**REPAIR AND PREVENTATIVE MAINTENANCE
OF THE
HAMILTON AVENUE SCHOOL
PARKING GARAGE**
Greenwich, Connecticut
BID NO. 2529-25

ADDENDUM NO. 3

Date: April 23, 2025

NO.		DATE		BY	
REVISIONS					
PROJECT					
GARAGE REPAIR AND PREVENTIVE MAINTENANCE					
GARAGE SURFACE LEVEL DEMOLITION PLAN					
SEAL & SIGNATURE		DATE: APRIL 2025 PROJECT NO: 23120.00-2 DRAWN BY: L.E. CHECKED BY: J.C. DWG No: DM-001.00			
		CADO FILE No:

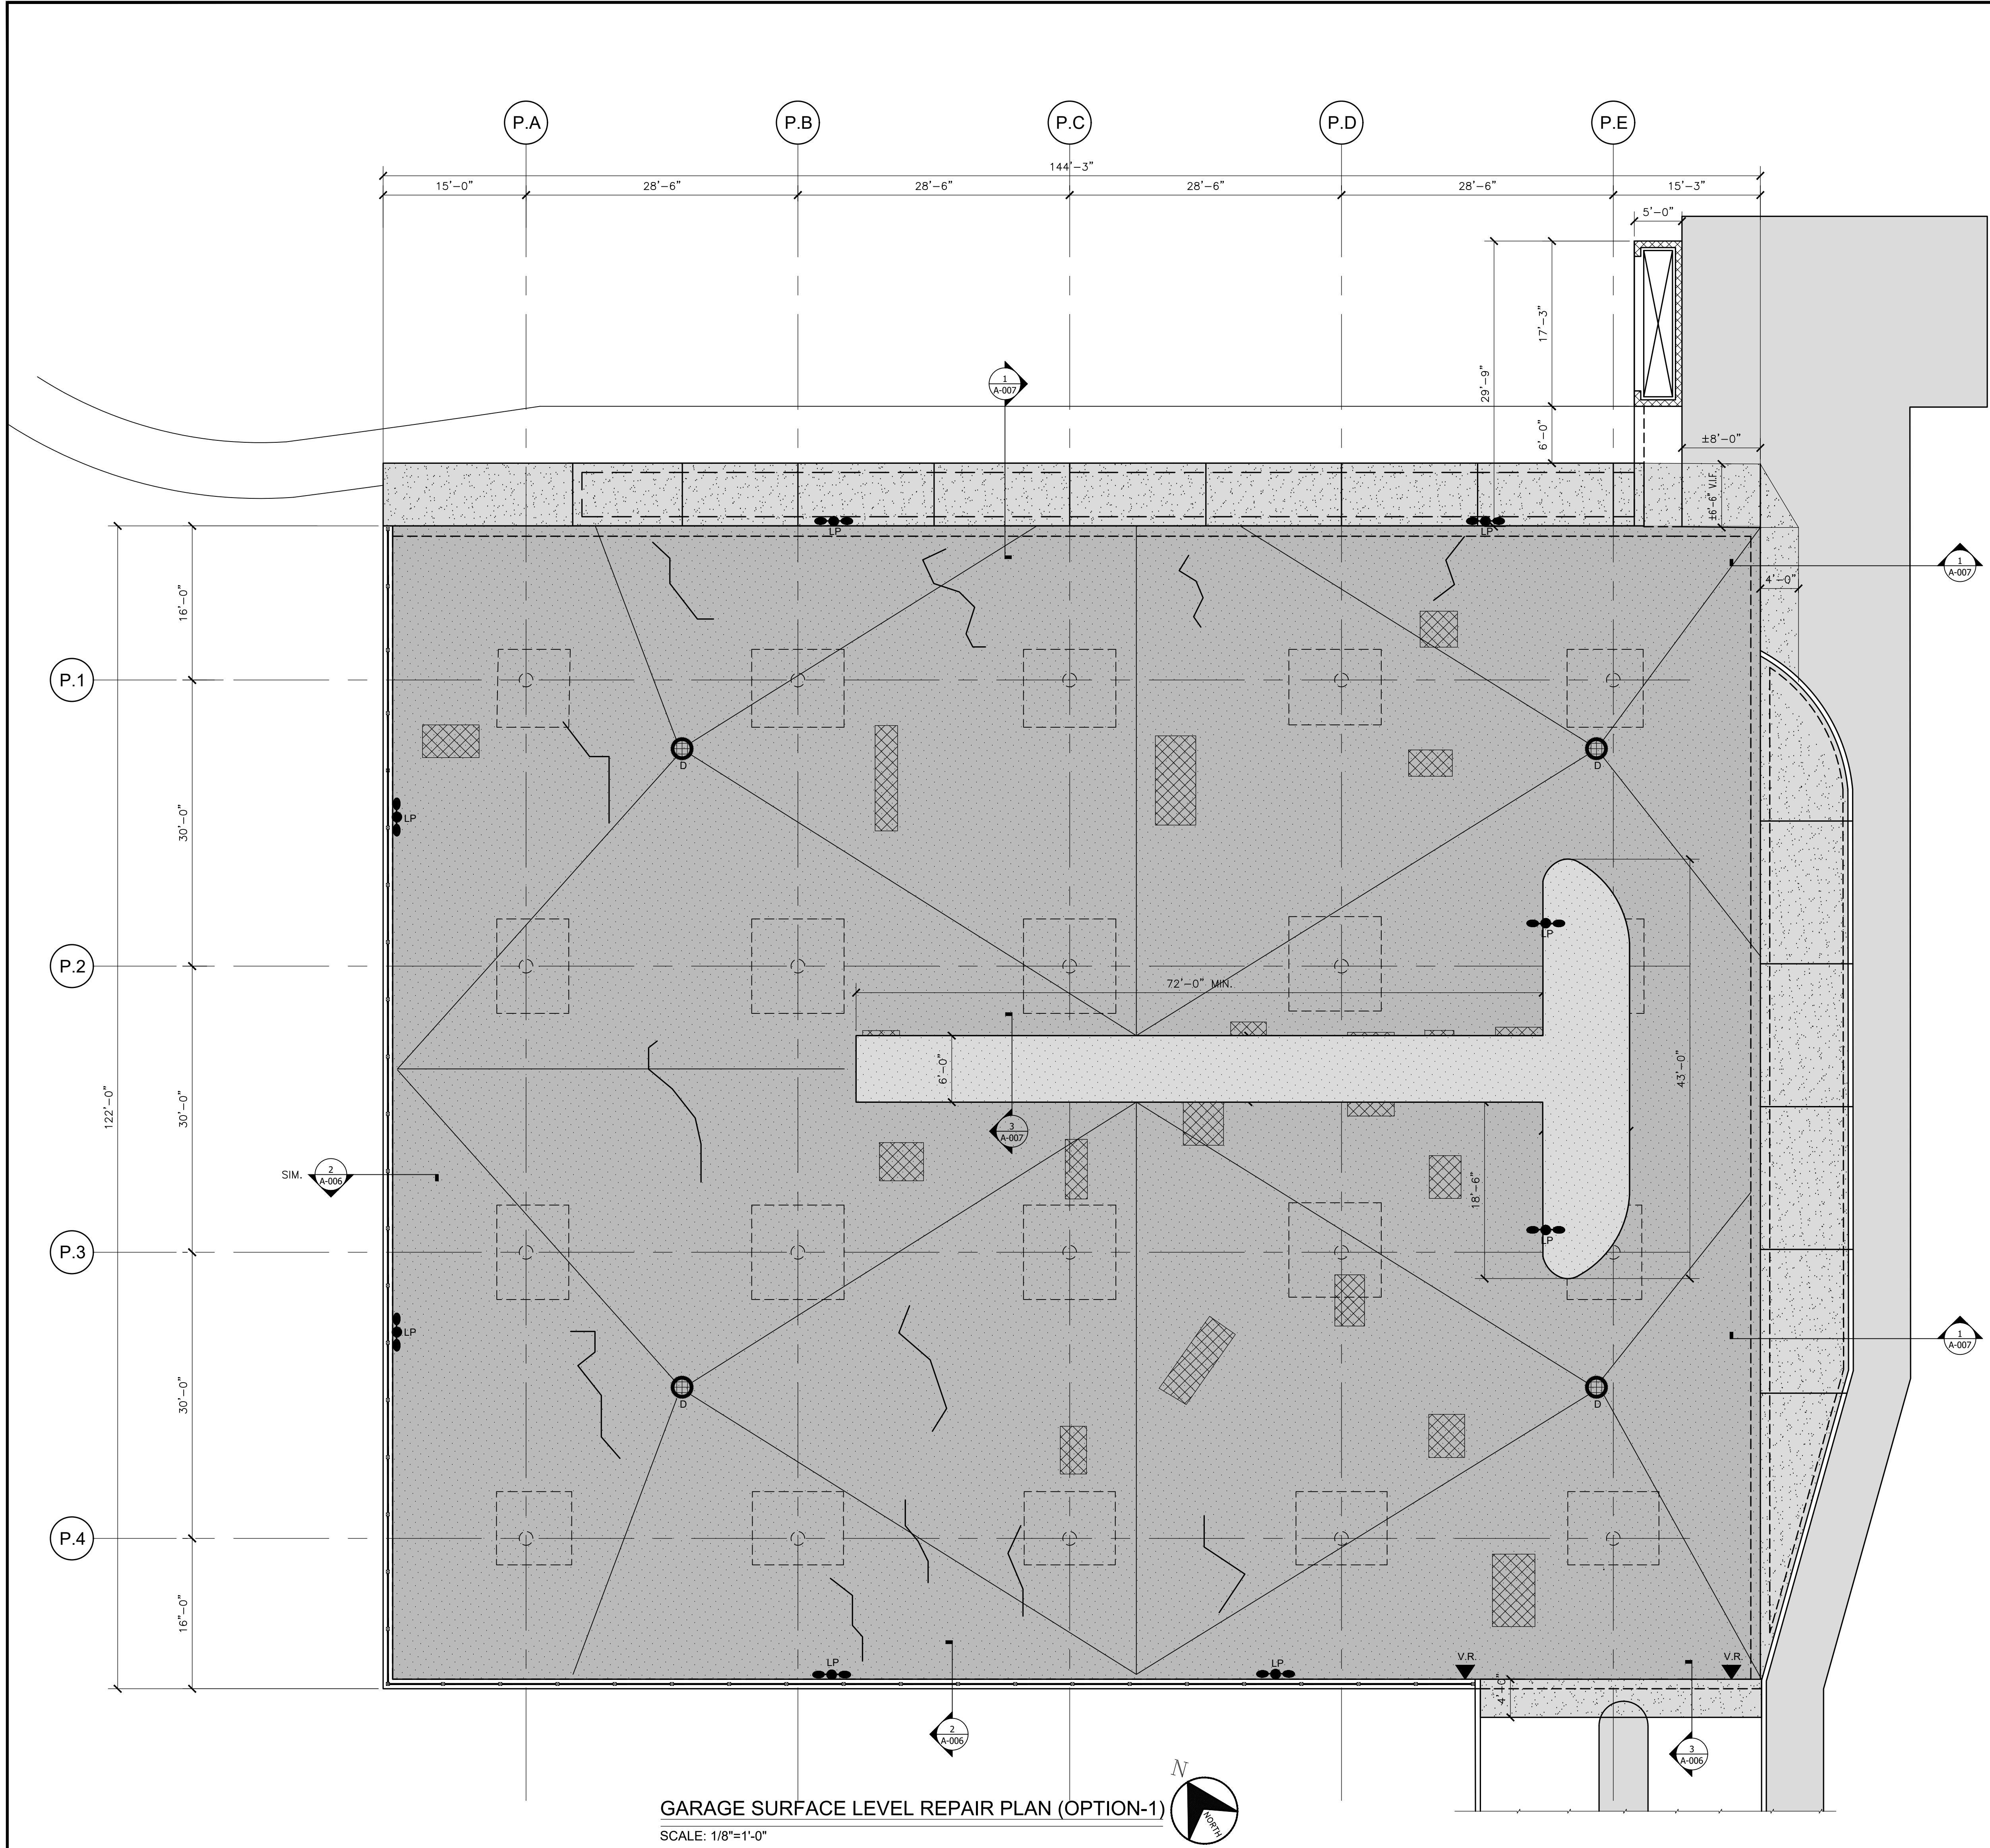
- Drawings DM-001 & A-001 shows an elevated sidewalk & curb at the NE corner of the structural slab (See attached picture of existing condition) while the proposed striping plan (drawing A-003) shows the same space being used by a handicap stall.
- Please clarify and/or revise drawings.

See revised Addendum No. 3 Drawings for clarifications.

TYPICAL REPAIR DETAILS AND SECTIONS (OPTION-1)
--

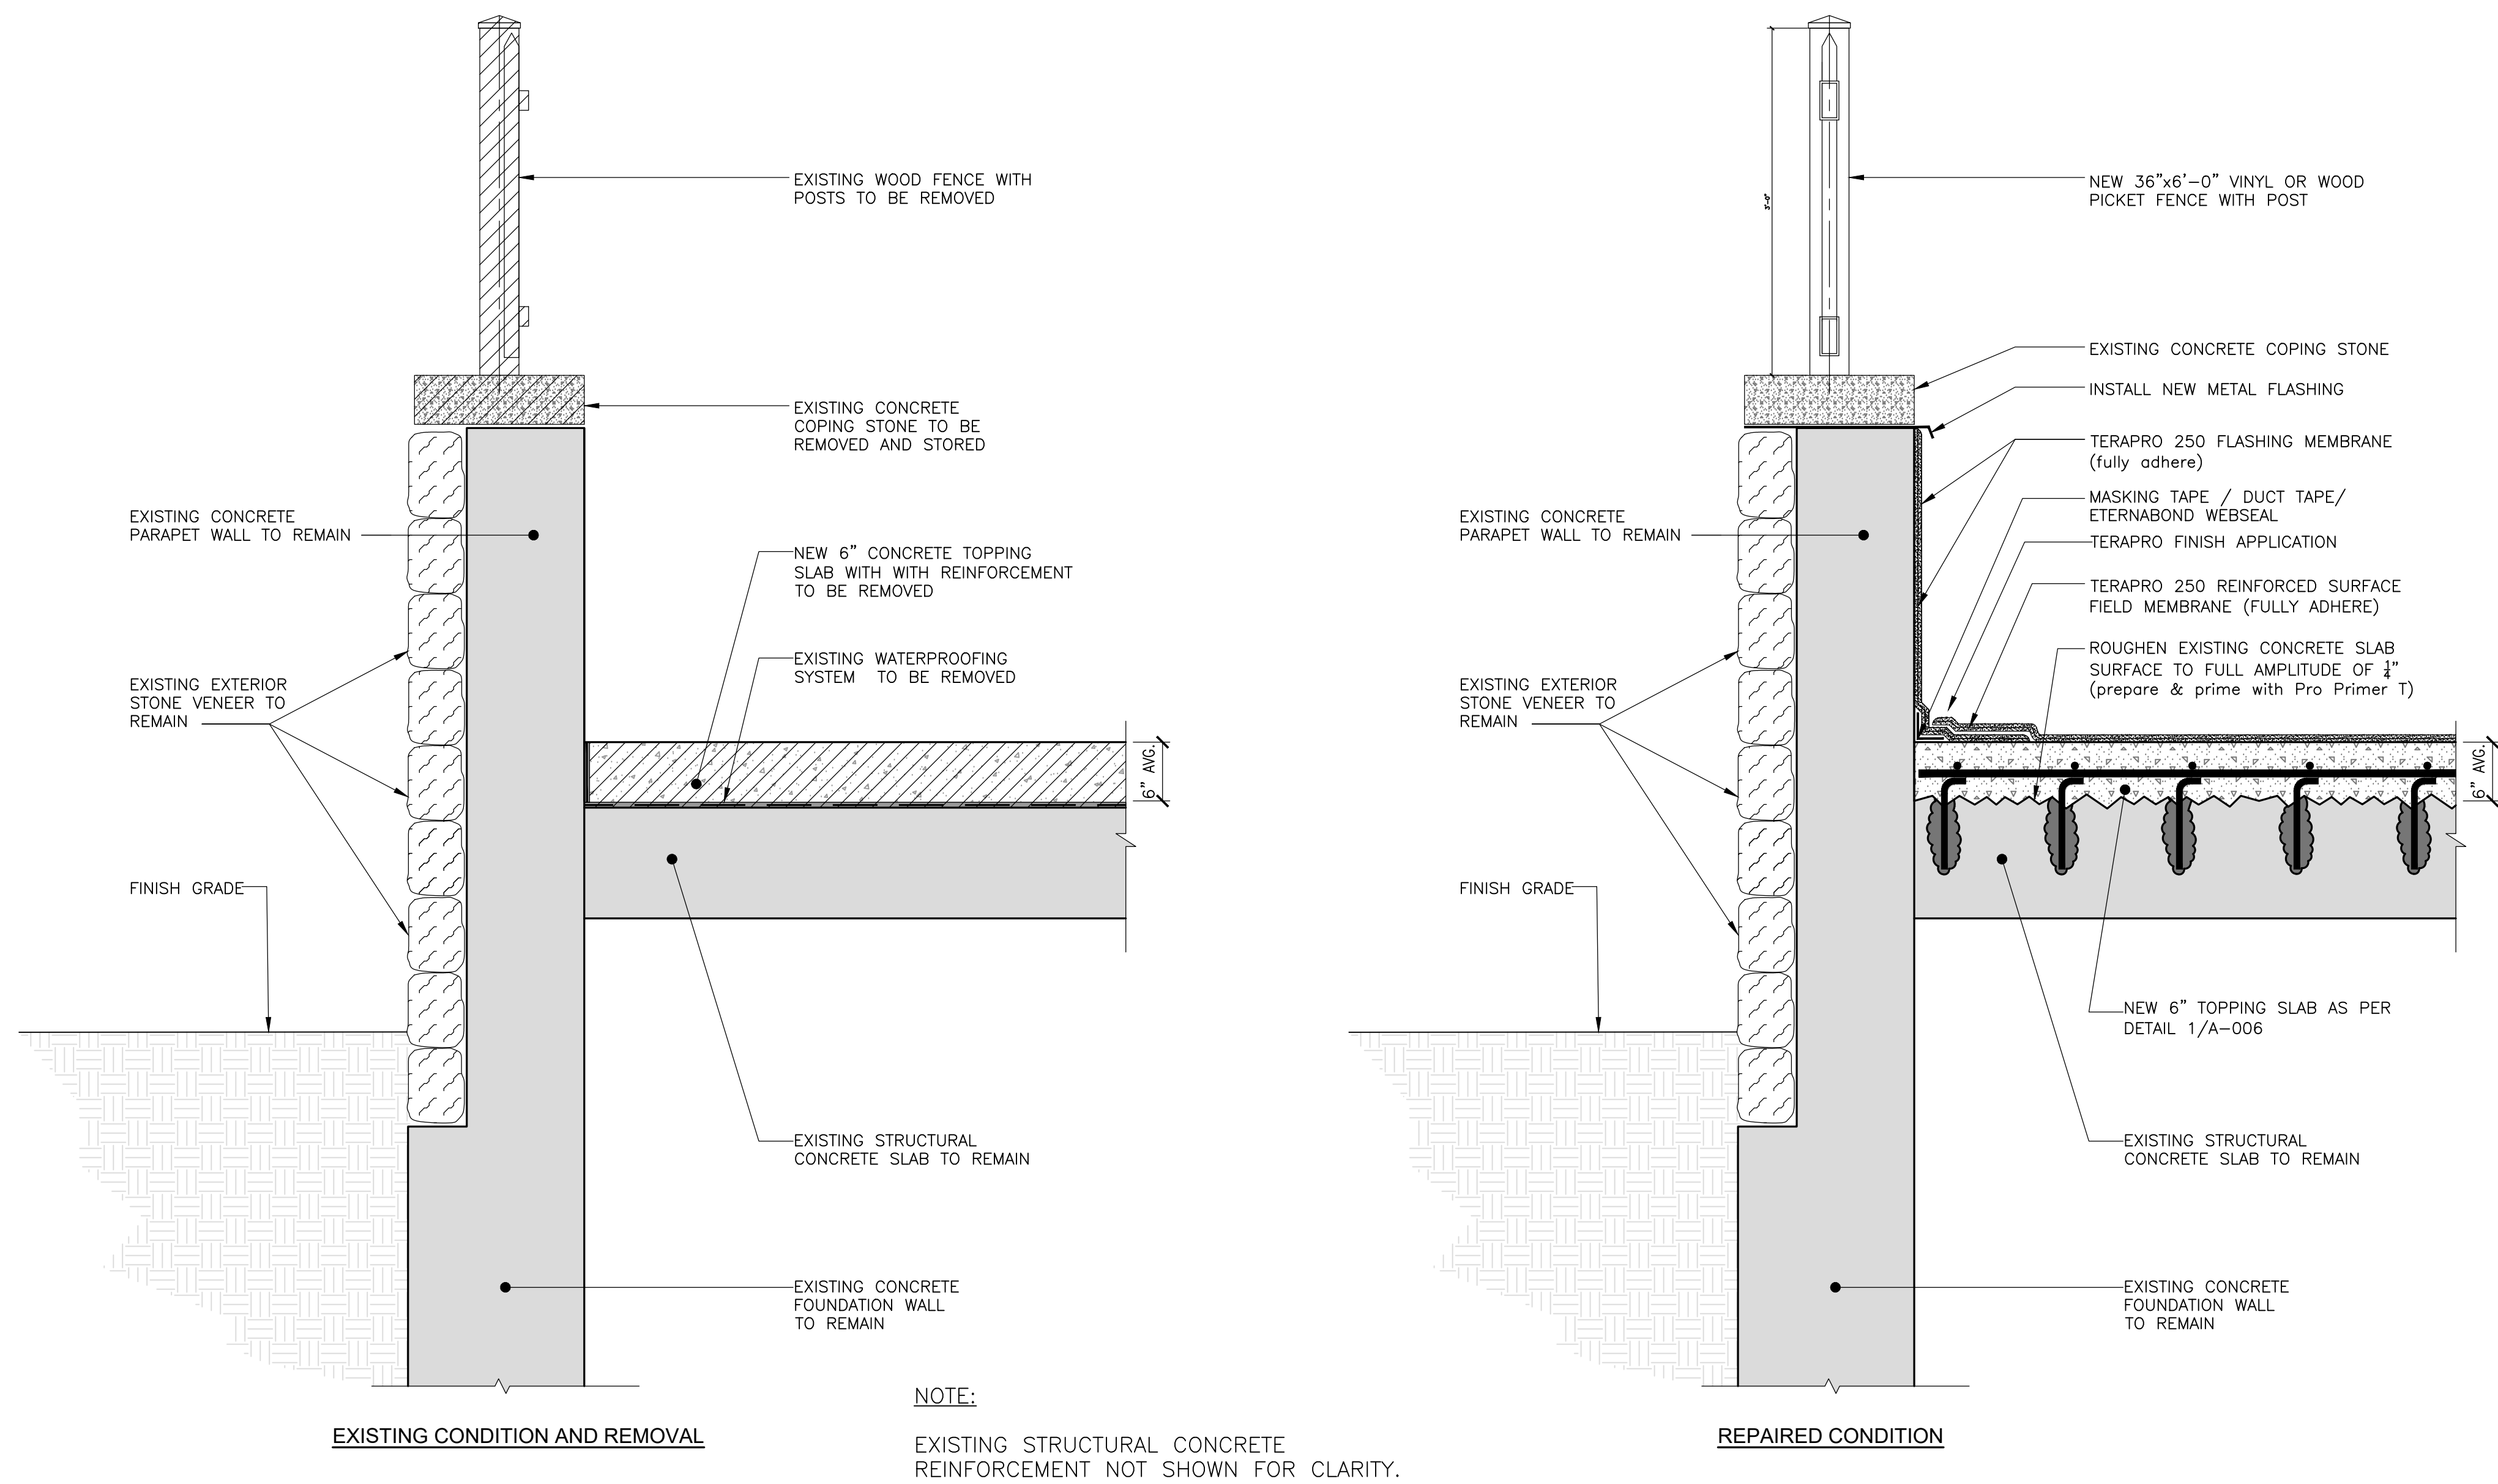
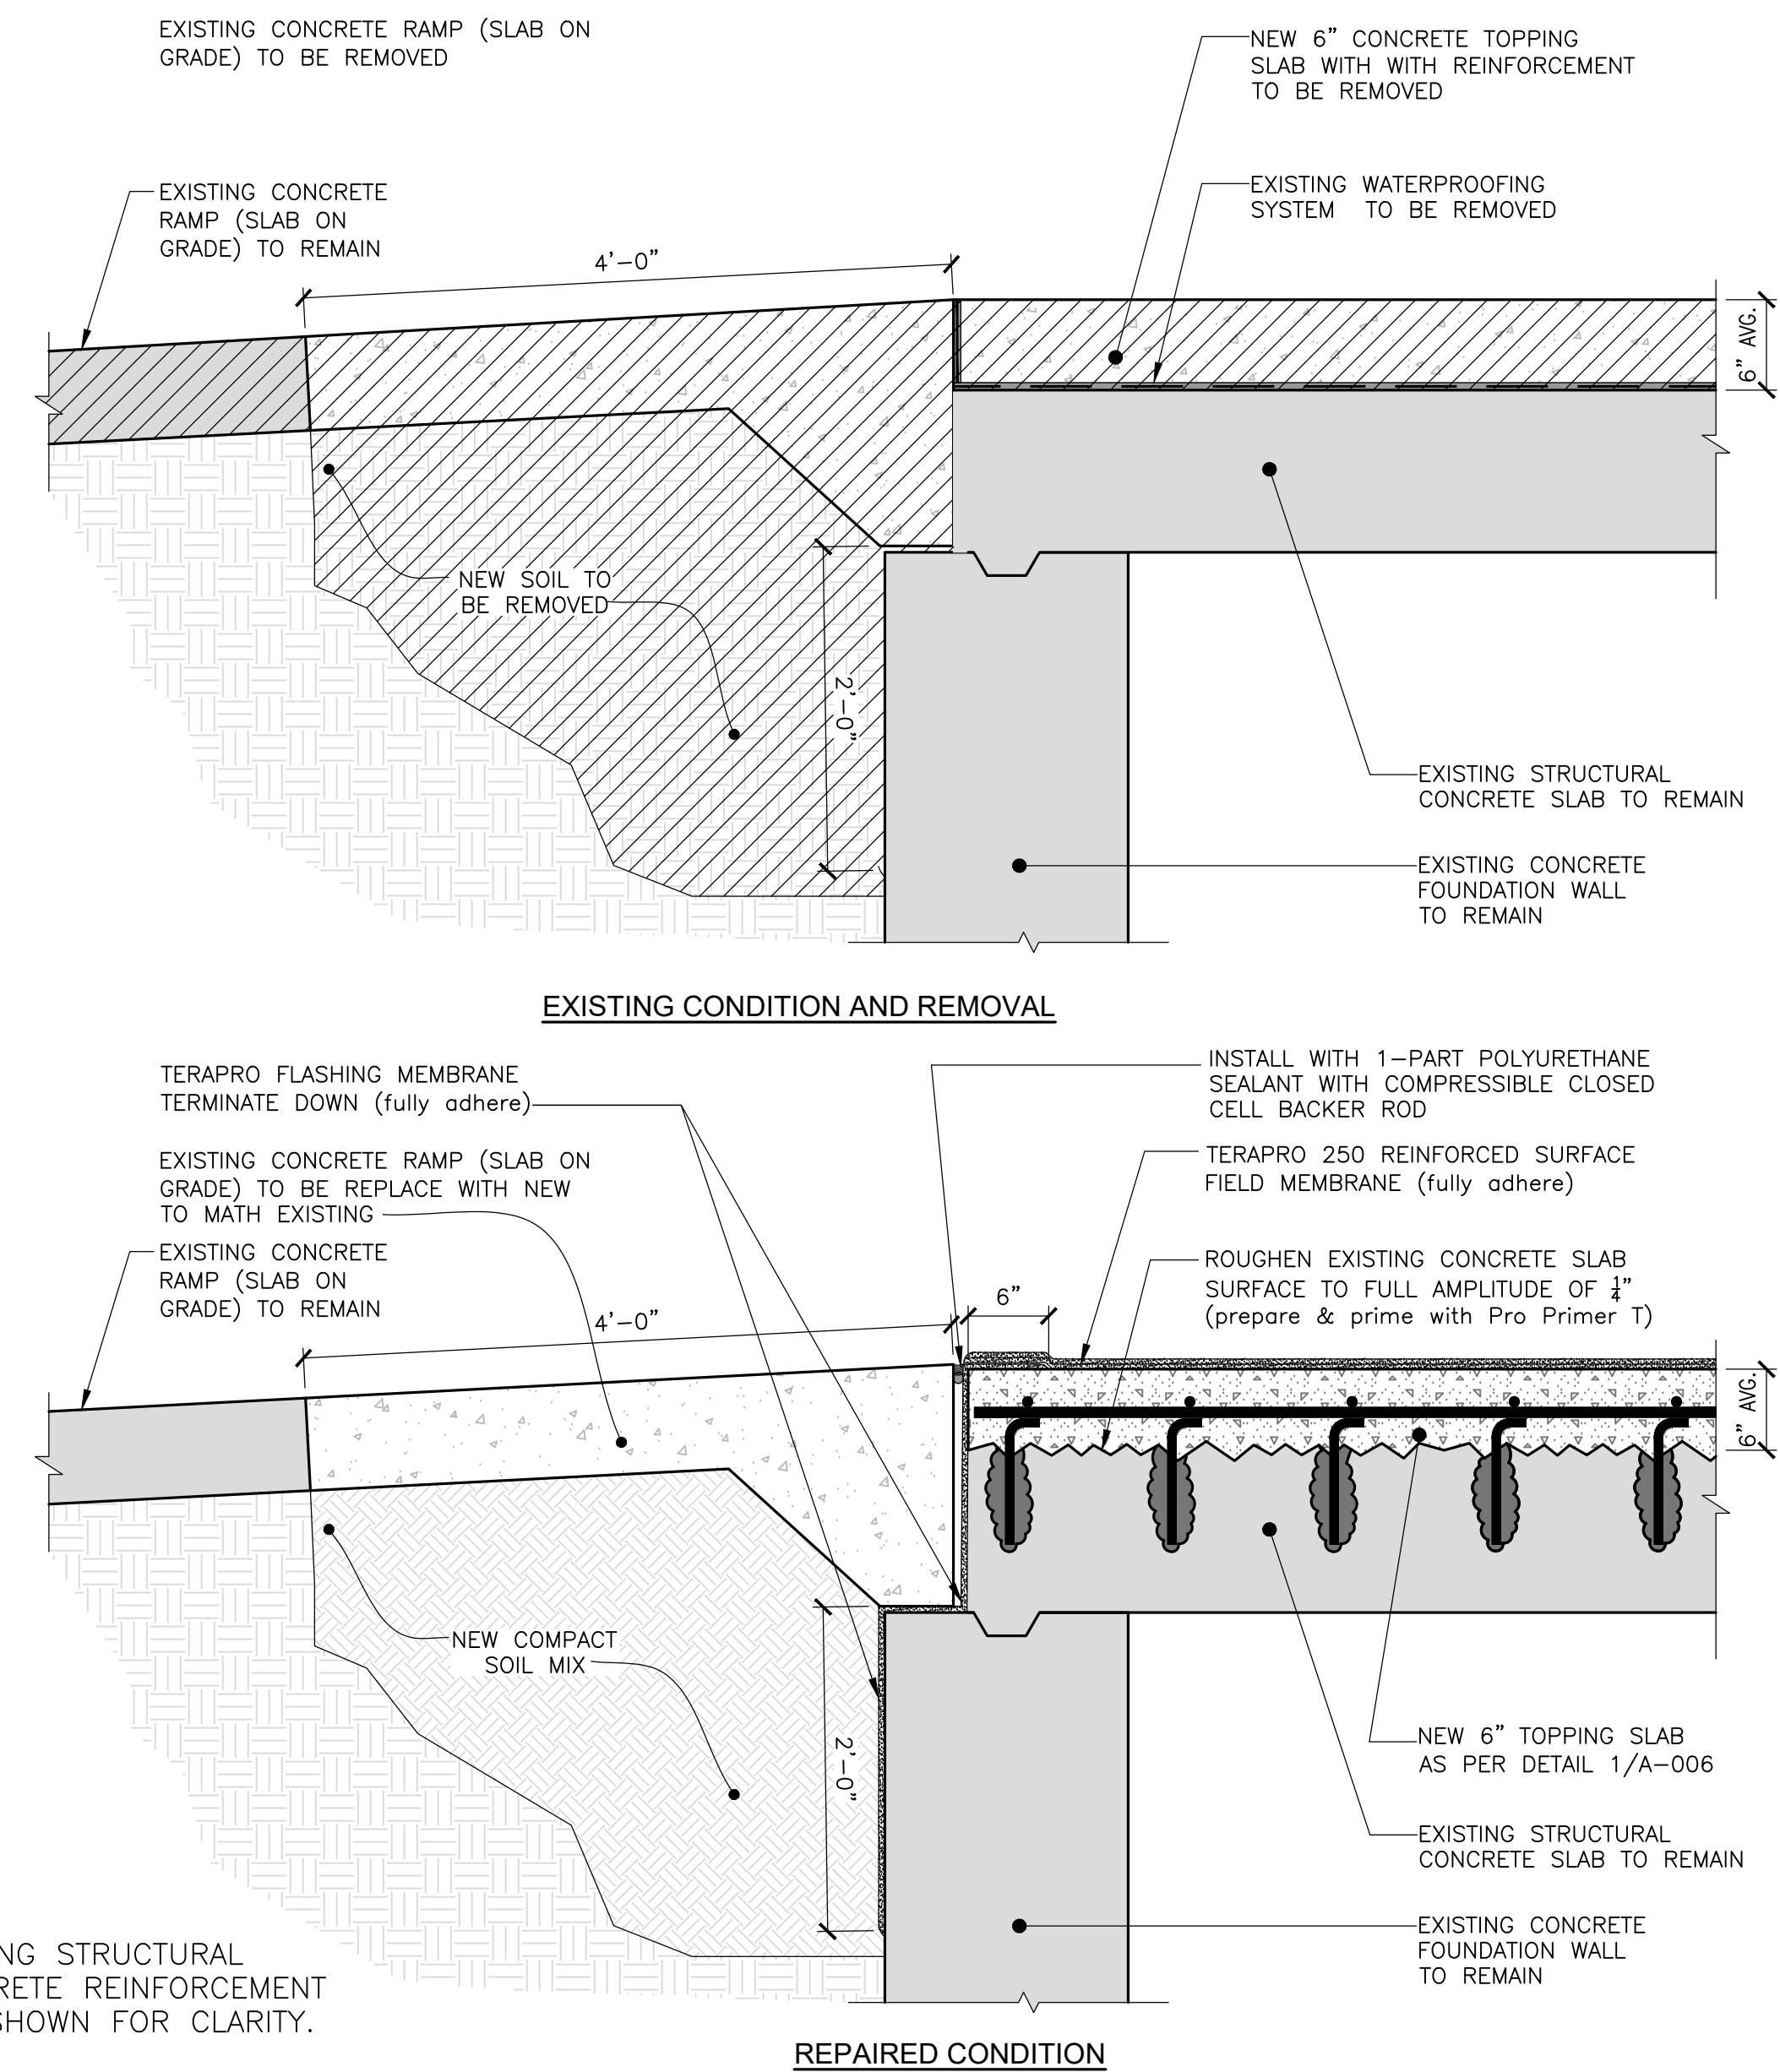
- Please clarify if we must include in this line item the sidewalk on grade reconstruction necessary to flash down the waterproofing as per details 3/A06 & 1/A07, since there is no line item for sidewalk replacement other than alternate 3.

- There is not line item for driveway slab replacement (120 SF) required to flash down the waterproofing at garage entrance. Please clarify.

**The sidewalk replacement is now included in Phase 1 of the Base Bid.
See revised Addendum No. 3 Bid Form for clarifications.**

See revised Addendum No. 2A Bid Form for clarifications.
